Access Compliance Report

Public Rights-of-Way

(Curb Ramps)

Intersection ID: 3322	Main Street: CANTERBROOK_DR	Cross Street: TURTLE_CROSS_LN	Location: NE
ADA ID: ADB680145078	Ramp Type: Perp	Initial Pass/Fail: Fail	Overall Compliance: No
Severity Score: 8.75			
Codes/Mitigation Info/Possible Solution		Field Measurements/Component Compliance

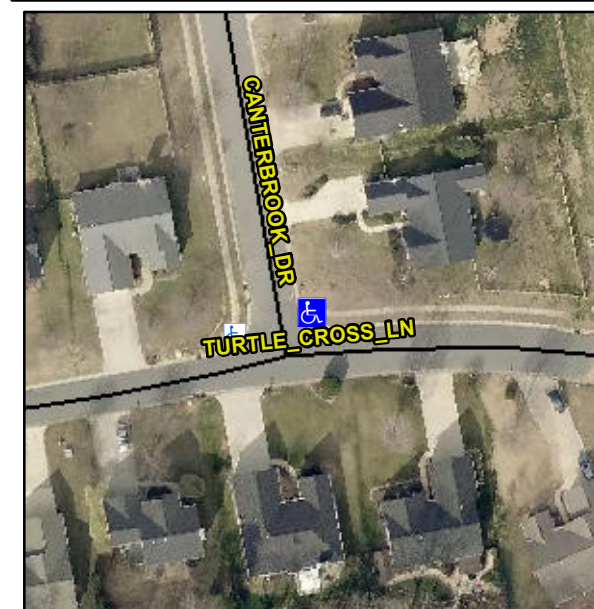
Not Found, R304.5.1

Compliance	Description	Data	Compliance	Description	Data
N/A	Ramp Length (in)	49.0	Yes	Ramp Slope (%)	5.3
No	Ramp Width (in)	42.0	Yes	Ramp XSlope (%)	0.5
N/A	Flare Type LT	N/A	N/A	Flare Type RT	N/A
N/A	Flare Slope LT (%)	N/A	N/A	Flare Slope RT (%)	N/A
N/A	Flare Traversable LT?	N/A	N/A	Flare Traversable RT?	N/A
N/A	Landing Length (in)	N/A	N/A	DWS Provided?	N/A
N/A	Landing Width (in)	N/A	N/A	DWS Contrast?	N/A
N/A	Landing Slope (%)	N/A	N/A	DWS Length (in)	N/A
N/A	Landing X Slope (%)	N/A	N/A	DWS Full Width?	N/A
N/A	Landing Curb? (Y/N)	N/A	N/A	DWS Offset (in)	N/A
N/A	Shared Landing?	N/A			
N/A	Gutter Ponding?	N/A	N/A	Gutter Slope (%)	N/A
N/A	Gutter Lip Ht (in)	N/A	N/A	Gutter X Slope (%)	N/A
N/A	Painted X Walk1?	No	N/A	Painted X Walk2?	N/A
	X Walk 1 Direction	To W		X Walk 2 Direction	N/A
N/A	X Walk 1 Width (in)	N/A	N/A	X Walk 2 Width (in)	N/A
	X Walk 1 Slope (%)	3.6		X Walk 2 Slope (%)	N/A
	X Walk 1 X Slope (%)	0.1		X Walk 2 X Slope (%)	N/A

Remove & Replace Entire Ramp.
